Subject: Berlin, US2, L.S. 0063+88 ~ 0072+86 LT and Barre Town L.S. 0+00 ~ L.S. 3+70 LT and East Montpelier, US2, L.S. 0000+00 ~ 0065+47 LT

**VERMONT AGENCY OF TRANSPORTATION  
State Highway Access and Work Permit**

# **Cross Vermont Trail on State land between Route 2 and Winooski River in Berlin, Barre Town and East Montpelier.**

## CVTA Route 2 Project - comments response 2018-08-06

TITLE: RT 2 CROSSING DETAIL (page 1 of 4) Traffic signs existing conditions.

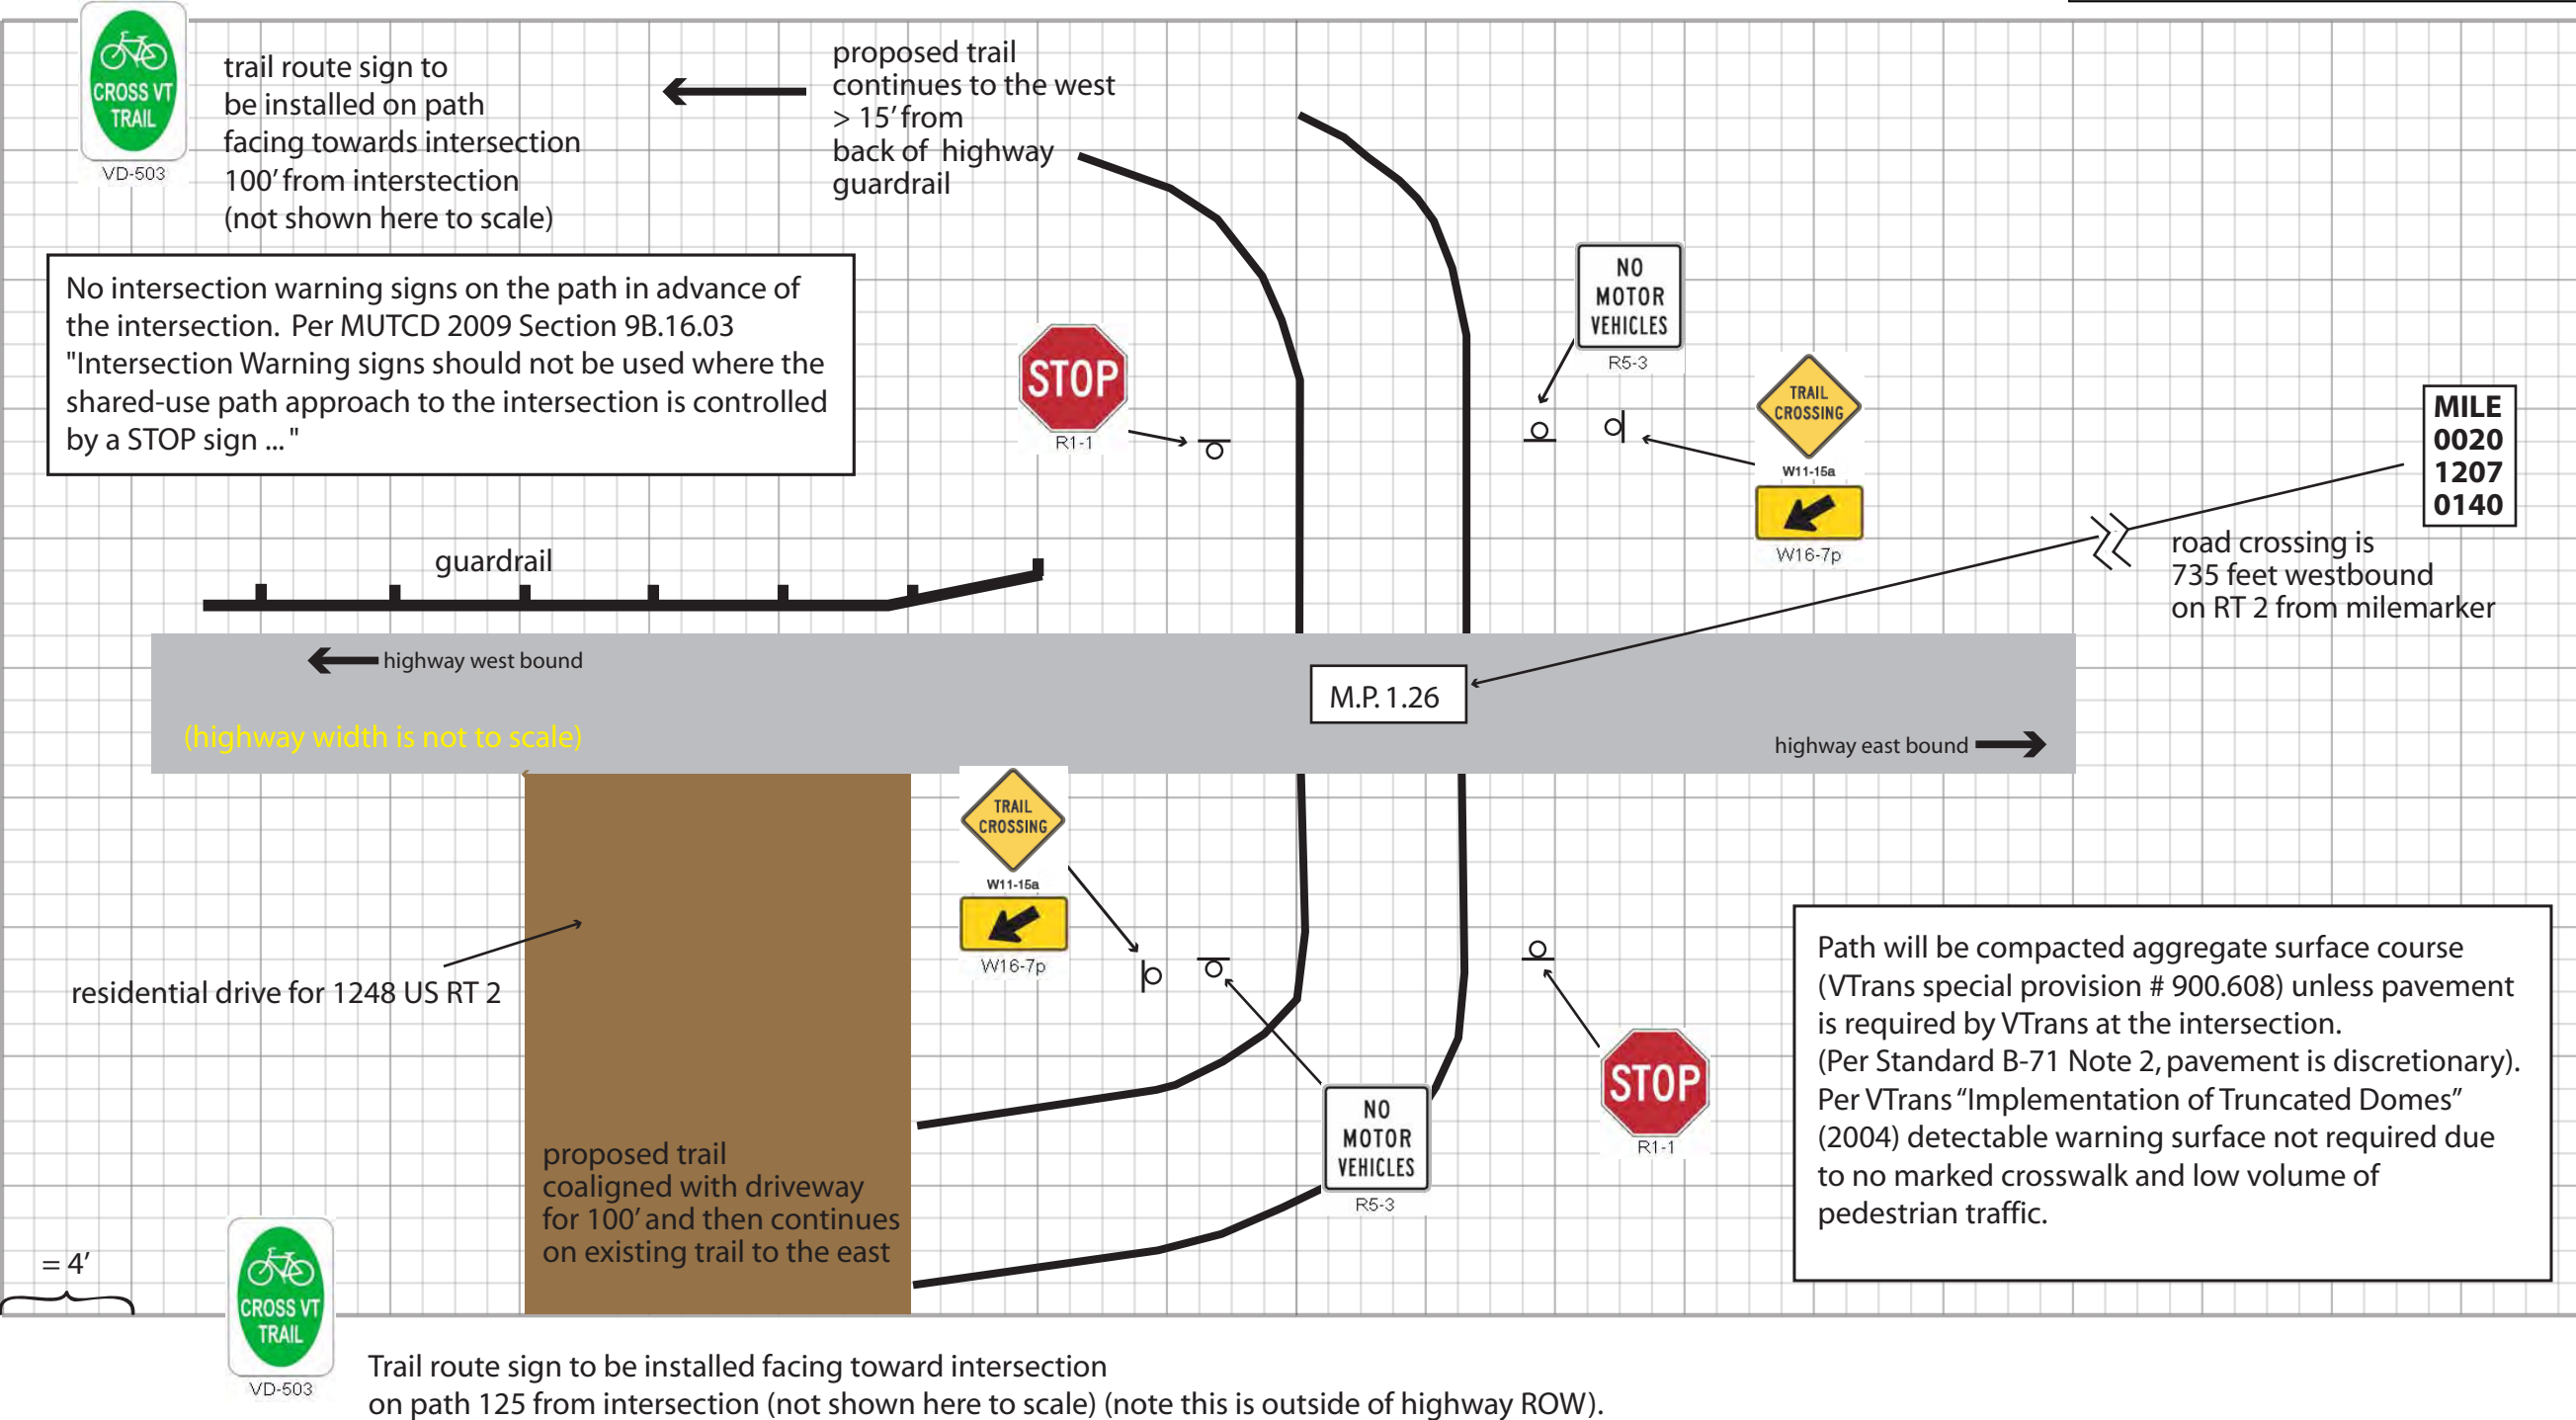
#	who	comment	response	sketch pg name	sketch pg #	comment pg #	pdf pg #
40	christopher.mercon@vermont.gov	the standards on this have changed, We currently use W11-15a signs to indicate trail crossings along with the plaques you have shown.	Revised.	Rt 2 Crossing 1	19	23	45
41	christopher.mercon@vermont.gov	Crossing at M.P. 1.26. References to each sign in mile point would be really helpful.	Done.	Rt 2 Crossing 1	19	23	45
42	christopher.mercon@vermont.gov	New standards have been established. Cite agency documentation vs citing agency employees.	Done.	Rt 2 Crossing 1	19	23	45
43	christopher.mercon@vermont.gov	Minimum spacing of 200' is required. (125' used)	Sign plan revised to comply with 200' spacing.	Rt 2 Crossing 1	19	23	45
44	christopher.mercon@vermont.gov	Hidden Drives (VW-060)	Sign plan revised to add this detail.	Rt 2 Crossing 1	19	23	45
45	christopher.mercon@vermont.gov	Folding sign New as part of 2017 Sign project. Possible removal/movement Per General sign locations in VTRANS TEI 16-200. no signs placed between warning sign and condition being warned for.	Proposed sign plan is one option. Any other variation preferred by VTrans to correctly sign the trail crossing would also be OK.	Rt 2 Crossing 1	19	23	45

46	christopher.mercon@vermont.gov	200' minimum spacing per TEI 16-200.	Sign plan revised to comply with 200' spacing.	Rt 2 Crossing 1	19	23	45
47	christopher.mercon@vermont.gov	typo	typo - fixed	Rt 2 Crossing 1	19	23	45
48	christopher.mercon@vermont.gov	Any signs indicating the US-2 intersection?	None required.	Rt 2 Crossing 2	20	24	47
49	christopher.mercon@vermont.gov	See note on detail page 1		Rt 2 Crossing 2	20	24	47
50	christopher.mercon@vermont.gov	[graphic is numbered as a comment]		Rt 2 Crossing 2	20	24	47
51	christopher.mercon@vermont.gov	Please indicate sign sizes and installation details for each sign or use a traffic sign summary sheet.	Done.	Rt 2 Crossing 2	20	24	47
52	christopher.mercon@vermont.gov	Bollards? Detectable warning surfaces? Stop Bars?	No bollards in highway ROW. Detectable warning surface not required in low use rural setting.	Rt 2 Crossing 2	20	24	47
53	christopher.mercon@vermont.gov	[graphic is numbered as a comment]		Rt 2 Crossing 2	20	24	47
